RE: Madisonville, Elementary School  
117 CS Owens  
Madisonville, La.

Dammon Engineering was contacted to inspect the rigid frame, Portal Frame, assembly that was installed in the cafeteria.

RIGID FRAME DETAIL  
N.T.S.

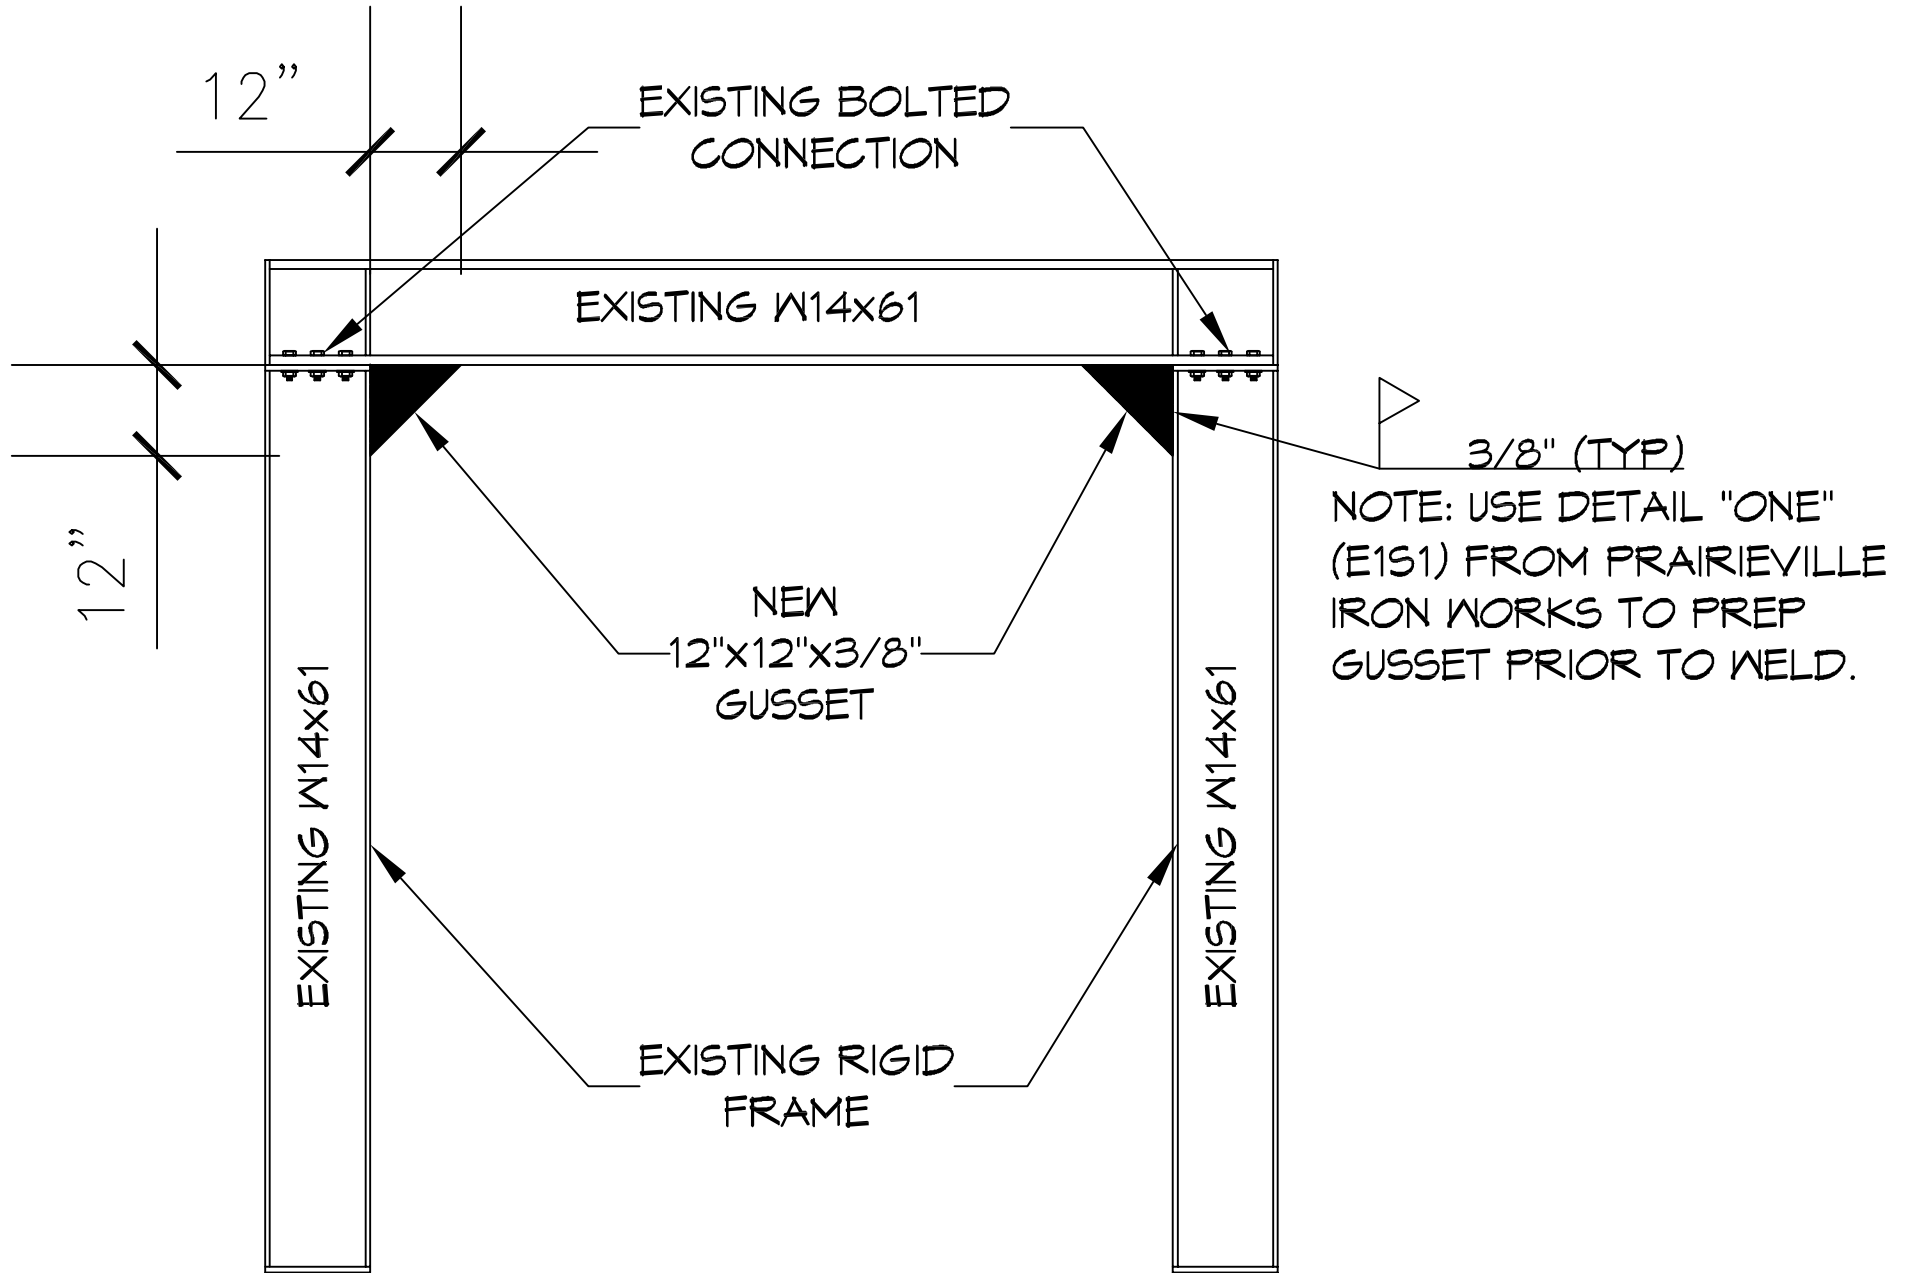
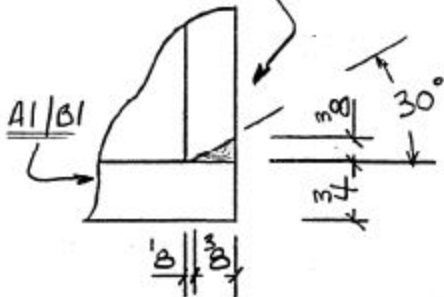
An inspection revealed that this rigid frame was constructed using three each W14x61's. The connection between these members was made using the horizontal's W14x61 member's bottom flange which is bolted to an end plate on top each of the vertical W14x61 members. Each connection was constructed using six each  $\frac{3}{4}$ " A325 bolts. See detail attached detail.

Analysis of the rigid frame was performed and found that the although the connections would be capable of resisting shear and axial loads it would not properly resist the moment caused by wind forces.

We recommend that two each 12"x12"x $\frac{3}{8}$ " thick triangular gussets be installed per the attached detail.

GRIND WELDS  
FLUSH @ OUTSIDE FLG'S
